SLAC MEMORANDUM

August 1, 2005
RSO-05-07

Title: L-Band RF Penetration in the NLCTA roof

Subject: Analysis of the New L-band RF Penetration in the NLCTA Roof
To: Sayed Rokni
From: Hesham Khater

Fig. 1. Elevation view of the NLCTA roof penetrations.

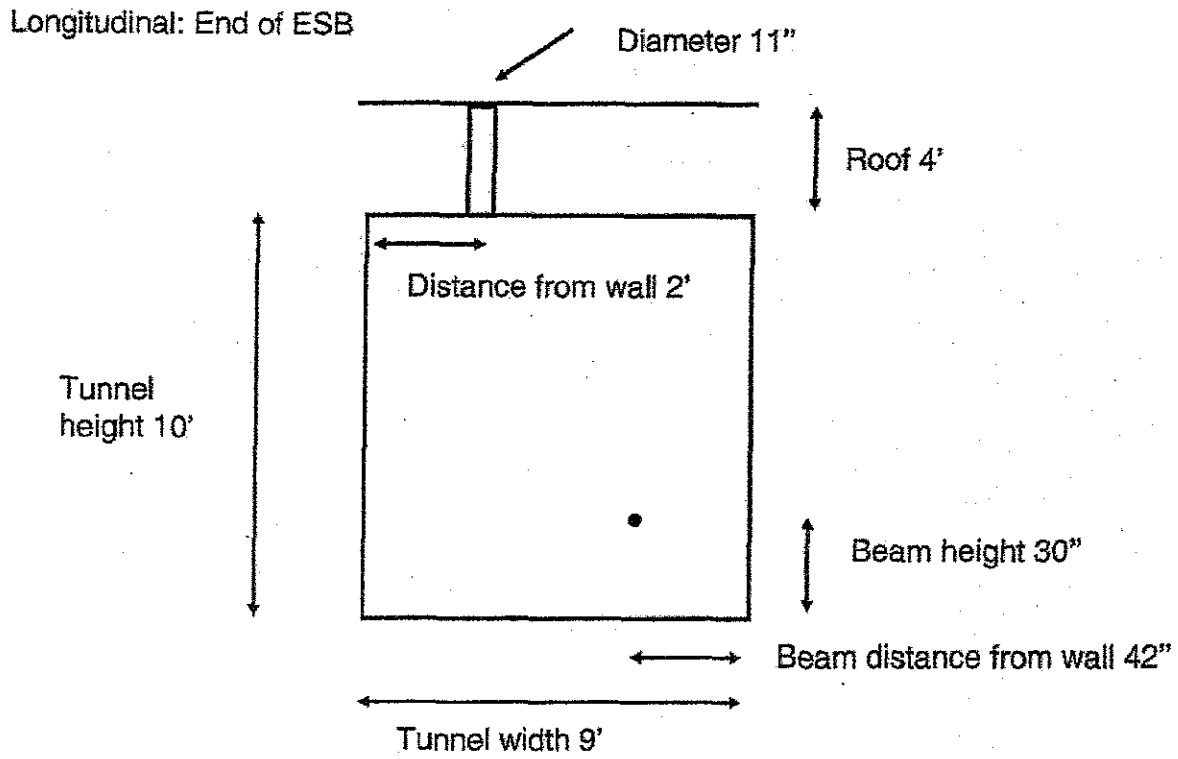
I analyzed the request¹ from S. Doebert to add a new penetration to the roof of the NLCTA. The radiation safety analysis of the new penetration has been documented in a Radiation Physics Technical Note (RP-TN-05-13, June 22, 2005). I conclude that adding the new penetration to the roof of the NLCTA may proceed under the following conditions:

1. The space between the 11"-diameter hole and the RF waveguide is filled with equivalent shielding material (e. g., gravel).
2. The penetration is blocked when not in use.
3. Proper RSWCF is issued.

The ILC group requested adding a new penetration to the roof of the NLCTA [1]. The new penetration will be used for L-band RF waveguide. The standard waveguide size is 6.5" x 3.25" but the associated flanges require an 11"-diameter hole. Figure 1 shows an elevation view indicating the position of the new penetration relative to the NLCTA beamline. The waveguide will be connected to L-band structure located in the high energy region of the NLCTA beamline. The level of radiation streaming through the penetration was analyzed for the nominal and safety envelop beam powers previously analyzed [2] and included in the NLCTA safety Assessment Document (SAD) [3]. In addition to radiation streaming through the penetrations, direct dose rates are also calculated on the top of the 4'-thick concrete.

1. The space between the 11"-diameter hole and the RF waveguide (option II) is filled with equivalent shielding material (e. g., gravel).
2. The penetration is blocked when not in use.
3. Proper RSWCF is issued.

Fig. 2. Elevation view of MCNPX model.

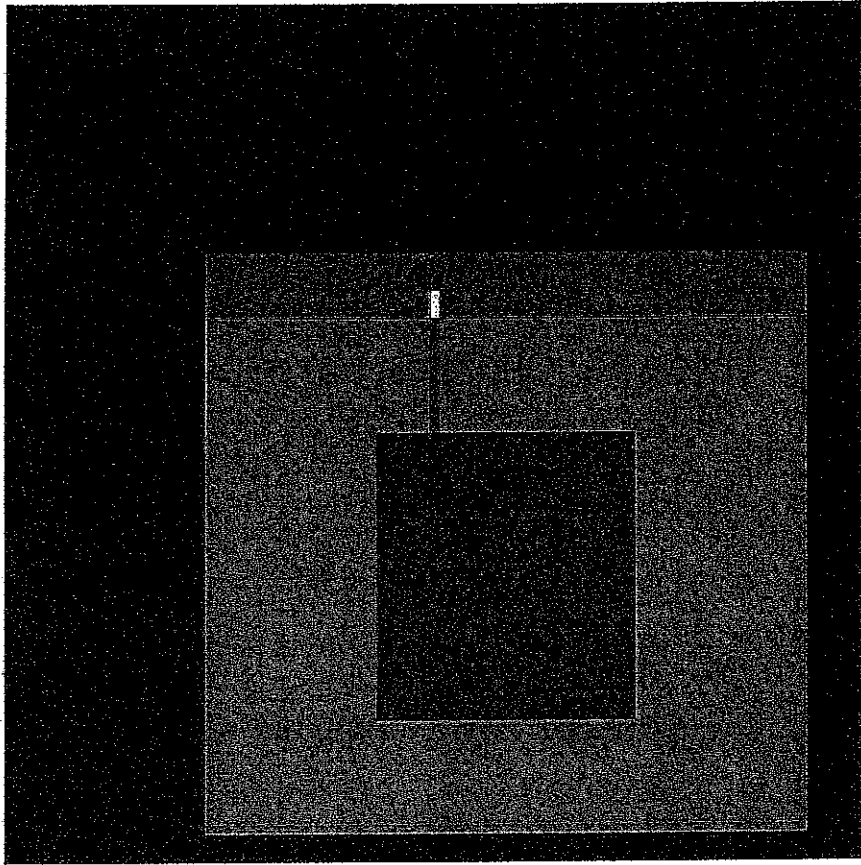
In order to calculate the dose rates outside the penetration, a Monte Carlo simulation was performed using the MCNPX code [4]. The MCNPX code was run with incident electron kinetic energy of 1.1 GeV, and with electron cutoff energy of 1 MeV. The kinetic energy represents the highest possible energy included in the NLCTA SAD. The beam was assumed to hit a 12"-long cylindrical copper target which has a 2" radius. Results obtained for the maximum energy and power (5747 W) specified by the SAD (safety envelop for upgraded power level) were scaled for power levels specified for nominal operation (438 and 1451 W) as well as the safety envelop design power level (3233 W). Figure 2 shows the MCNPX model used in the calculation. In this figure, the inside of the NLCTA enclosure is shown in light blue, the enclosure concrete walls in light green, penetration in dark green, scoring region in yellow. In addition, the beam line is shown in dark blue. Finally, the two circles shown in blue are not part of the geometry and only represent DXTRAN spheres (for MCNPX variance reduction).

Calculations were performed for two penetration options. The first option (Option I) represents the requested 11"-diameter hole. On the other hand, the second option (Option II) assumes that the roof hole matches the actual size of the wave guide size (6.5" x 3.25"). Finally, dose rates resulting from radiation streaming through the penetrations were compared to direct dose rates on top of the 4'-thick concrete roof. The direct dose rates were calculated by using the SHIELD11 code [5]. Unlike the MCNPX calculations where dose rate results were obtained for the highest energy (1.1 GeV) and highest power (5747 W), the SHIELD11 calculations were performed for
